Response to referee-1 Nino Willi

Response to referee-2 Daniel Klose

Review “Optimized shaped pulses for 2D-SIFTER”

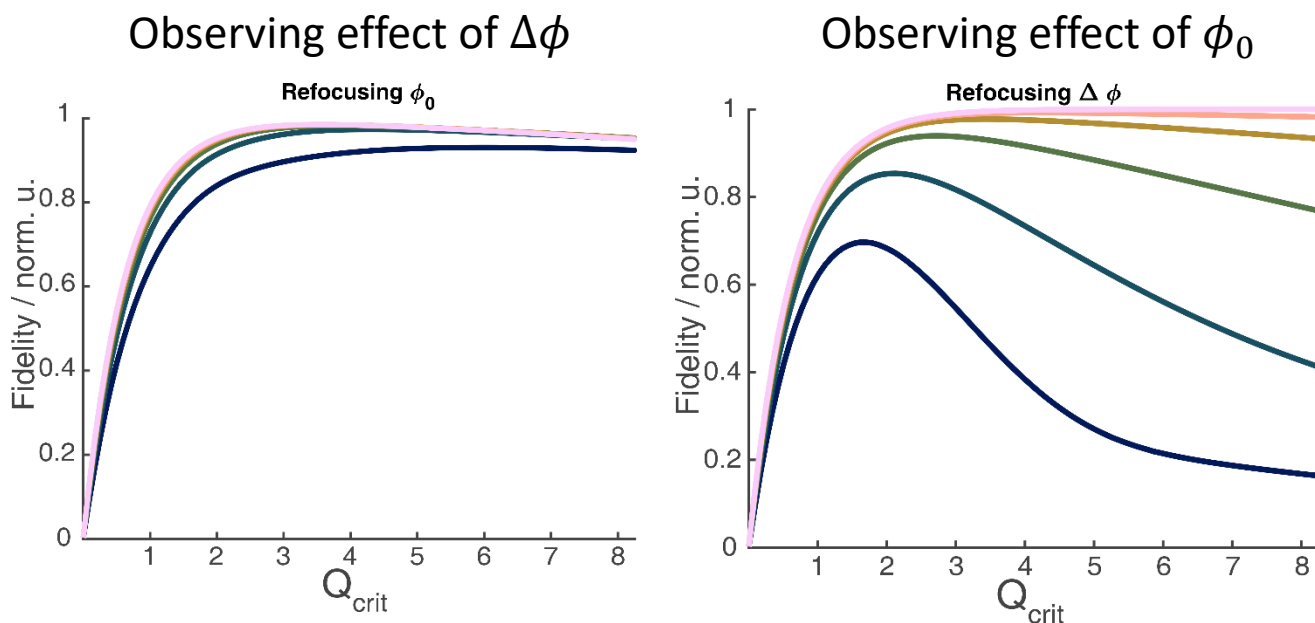
Point 2: Further, what is the direct consequence of the increasing B1-inhomogeneity, which causes the observed echo decline at high Q_{crit} ? Is it a more severe phase roll $\Delta\phi$? This is assuming that the fixed echo phases ϕ_0 have been corrected for each Q_{crit} . Is that the case?

Your question prompted us to try to investigate which of the two phase shifts ($\Delta\phi$ and ϕ_0) is the dominant source of the decline in Echo intensity with increasing Q_{crit} . For this we

have repeated the simulations in Figure 3, but in one case selectively phased ϕ_0 (not $\Delta\phi$) of the individual B1-inhomogeneity simulations before summation and in the other case tried to refocus $\Delta\phi$ but not ϕ_0 before summation. The results are shown in the following figures:

Here it is evident that the distribution of ϕ_0 is the dominant effect. While in absence of B1-inhomogeneity (pink trace) only $\Delta\phi$ causes a decline in echo intensity as discussed in the previous question. This highlights the importance of considering ϕ_0 and we have included these simulations in the appendix of the revised version. This observation is also consistent with our observations in Figure 1 and Figure 4. In Figure 1 we had already shown that ϕ_0 is large compared to $\Delta\phi$ (Line 200 (207 in revised version)) and that ϕ_0 depends on pulse length but $\Delta\phi$ does not (as long as all spins are inside the excitation bandwidth of the pulses). The different declines of echo-intensity in Figure 4 dependent on pulse length must therefore also be caused by ϕ_0 .
